May 10, 2002
L-02-054

**Subject: Beaver Valley Power Station, Unit No. 1 and No. 2
BV-1 Docket No. 50-334, License No. DPR-66
BV-2 Docket No. 50-412, License No. NPF-73
Reply to Request for Information Concerning BVPS Responses to
NRC Bulletins 2001-01 and 2002-01**

Attachment A

Figure 1
Cross-Sectional View of Reactor Pressure Vessel Head

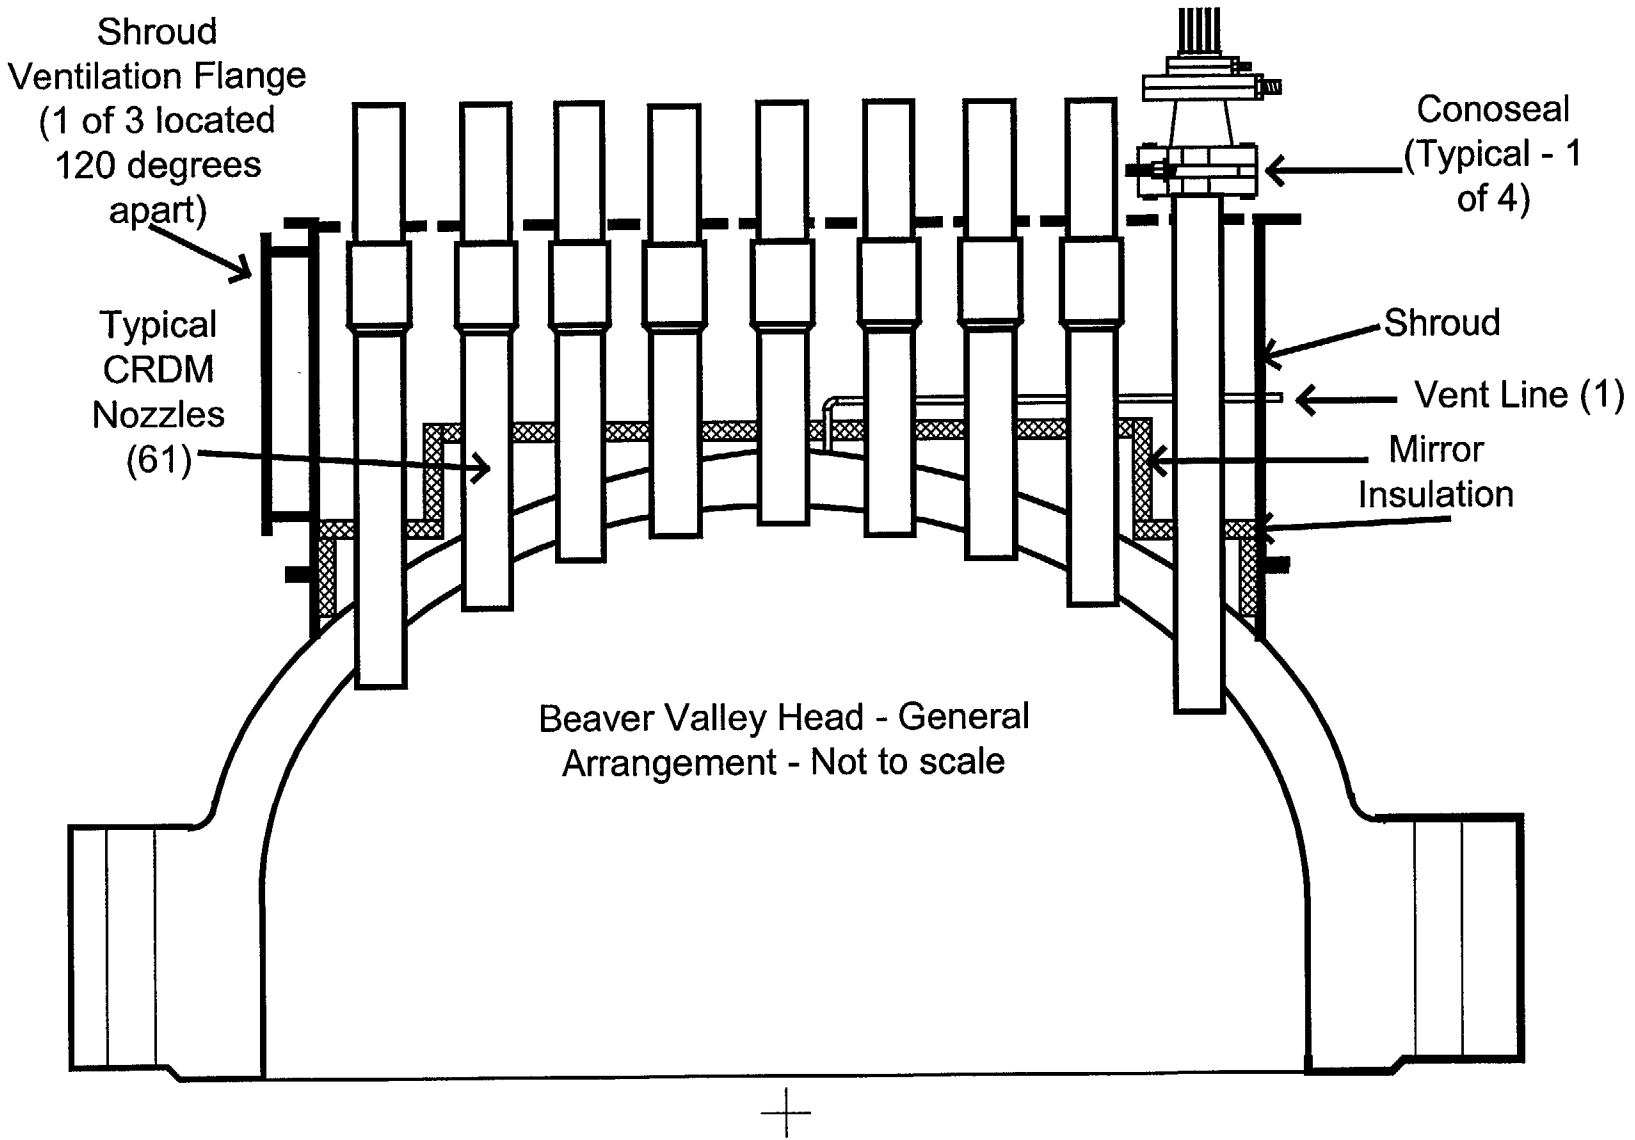
While efforts were made to clean up the spillage from the external conoseal leaks from above the insulation, we have concluded that the boric acid residue, which was identified in the inspection video, resulted from leakage that ran down onto the insulation from above and propagated through the joints and down onto the region of the head area. Access for cleaning under the insulation is difficult. See attached Figures 1 & 2 for a top view and cross-sectional view of the insulation in relation to the top of the reactor vessel head. The sectionalized insulation pieces at the outer portions of the head are not designed to be removed without the removal of the ventilation shroud. Access is limited

BV-1 Basic Insulation
Panel Orientation

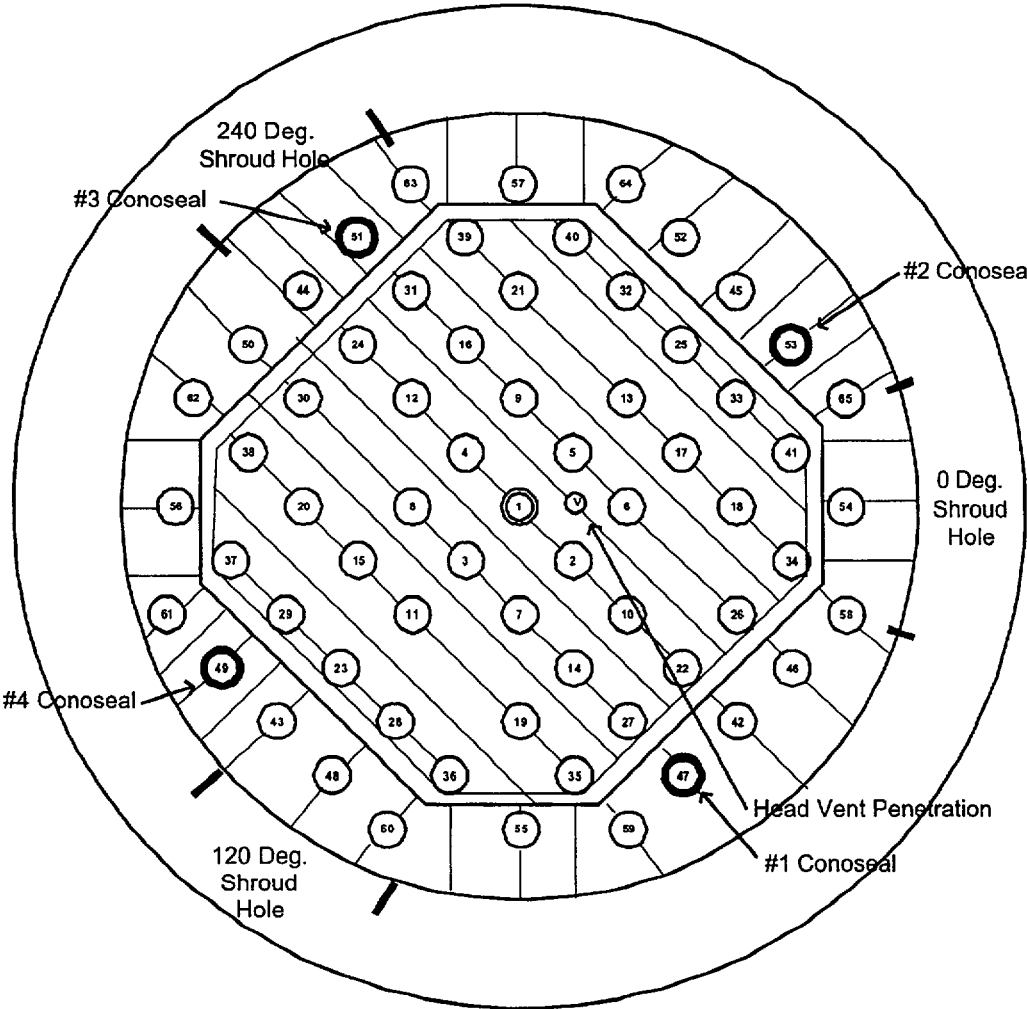
to individual outer sections by prying up a section of the insulation to get underneath for the purposes of inspection. In addition, the radiation levels in this region during shutdown periods are relatively high (ranging from 1000 mR/hour at the opening of the access ports to the head region to approximately 1500-2000 mR/hour at the upper portions of the head area) which also limits accessibility, consistent with ALARA.

BVPS Unit 2
Conoseal #1

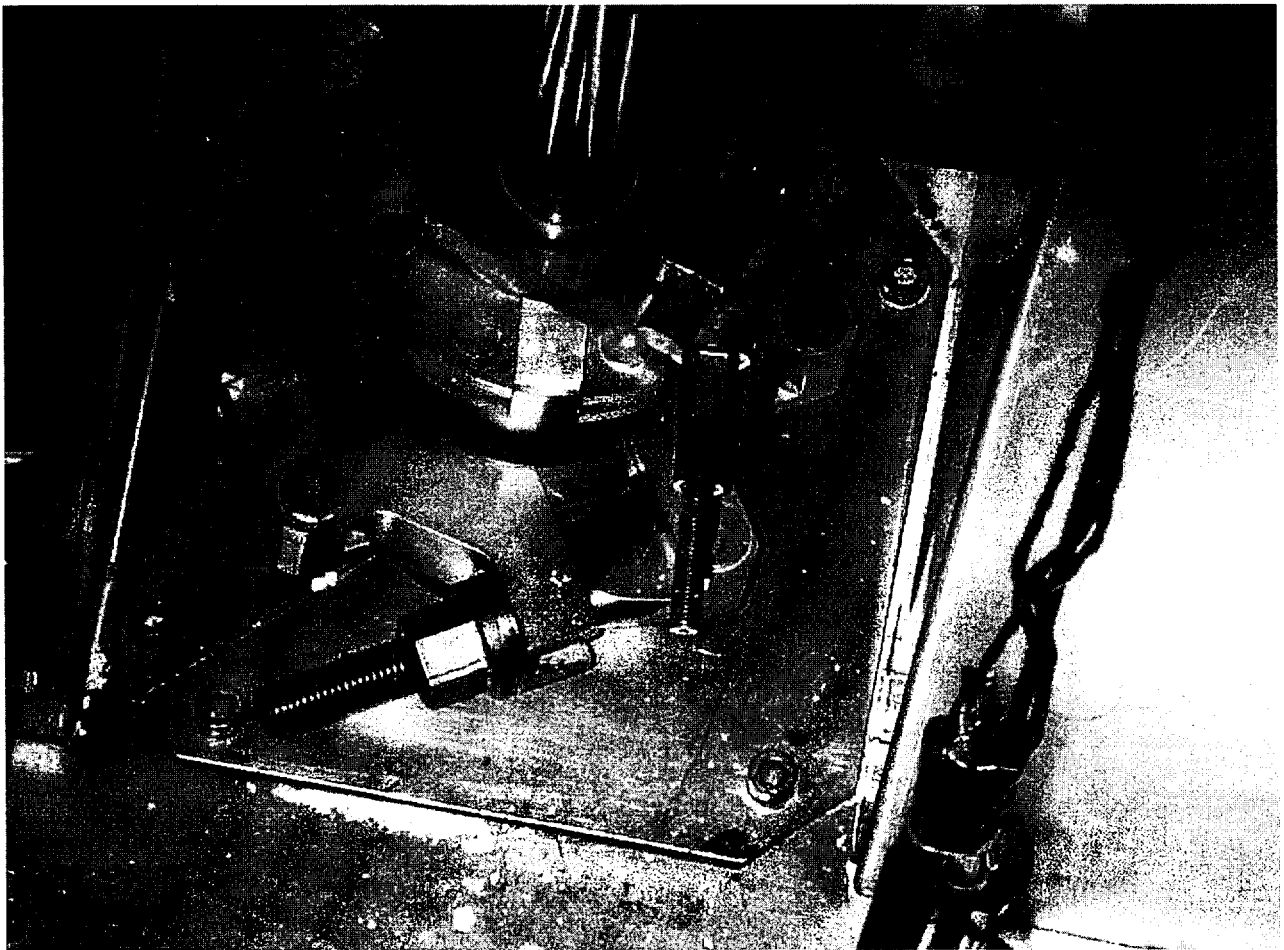
Were all known leaks repaired during the last Unit 1 and Unit 2 refueling outages so as to preclude the possibility of wetting of the deposits?

- At BVPS Unit 2, following the 2R09 refueling outage in February 2002, there was a light, dry dusting of boric acid observed on the upper surface of the #1 Conoseal when the system was initially pressurized to approximately 300 psi. Based on follow-up inspections of the area, it was determined that this was not an active leak. Additionally, during a subsequent forced outage on April 5, 2002, a containment entry was made and NDE personnel photographed the conoseal. The photos of the #1 Conoseal confirmed that there is no active leakage. (See Figure 3 which provides a copy of the subject photo.)

Photo taken during subsequent forced outage on April 5, 2002
(showing no evidence of active leakage)
